# UNITED STATES PATENT AND TRADEMARK OFFICE

APPLICATION NO.	FILING DATE	FIRST NAMED INVENTOR	ATTORNEY DOCKET NO.	CONFIRMATION NO.
10/711,289	09/08/2004	Robert G. Coulombe	GTAP:102US	5288
24041 7590 02/06/2007 SIMPSON & SIMPSON, PLLC 5555 MAIN STREET WILLIAMSVILLE, NY 14221-5406			EXAMINER MENEZES, MARCUS	
			ART UNIT	PAPER NUMBER
			3677

<b>Office Action Summary</b>	<b>Application No.</b> 10/711,289	<b>Applicant(s)</b> COULOMBE ET AL.	
	<b>Examiner</b> Marcus Menezes	<b>Art Unit</b> 3677

### **DETAILED ACTION**

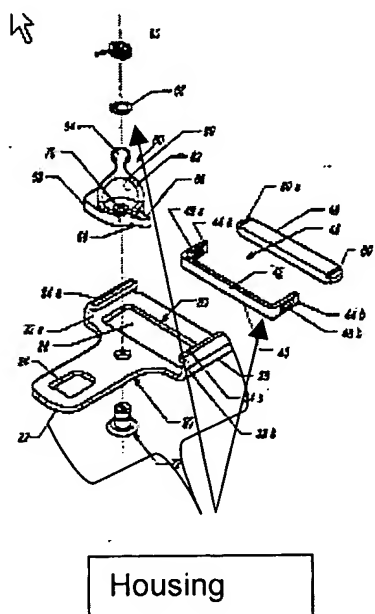
Ashline discloses a quick release buckle comprising a first cam (62); a knurl bar (48); and a first spring (80) engaged with said first cam and said knurl bar. (See Fig. 1 below). Ashline further discloses that said first spring is operatively arranged to apply compressive force against said first cam and said knurl bar. (See Figs. 2-3 and col. 2, lines 60-67). Also, said knurl bar is operatively arranged to grip a belt (90) in response to said compressive force. Moreover, a housing with an integral mounting structure (72) is disclosed; and wherein said housing has bearing walls that the first cam rests, said bearing wall being the top portion of the integral mounting structure (72); and wherein said first cam is operatively arranged to rotate about said mounting structure and wherein said housing further comprises first (20) and second (65) components and said mounting structure is integral to said first component. (See figure below). Additionally, said mounting structure is integral with said second component, is extruded from said housing and is operatively arranged to engage said first and second components.

Furthermore, Ashline discloses that said housing has a first mounting structure that is a protrusion fixedly attached to said housing and where a first cam pivotally mounted on said first mounting structure is operatively arranged to rotate about said first mounting structure.

However, Ashline does not disclose a second cam and a second spring operatively arranged to engage and said second cam and said knurl bar, pivotally mounted rotatably on said housing via a second mounting structure, and operatively arranged to apply a compressive force against said second cam.

On the other hand, it would have been obvious to one having ordinary skill in the art at the time the invention was made to have placed a second cam on the Ashline patent, since it has been held that mere duplication of the essential working parts of a device involves only routine skill in the art.
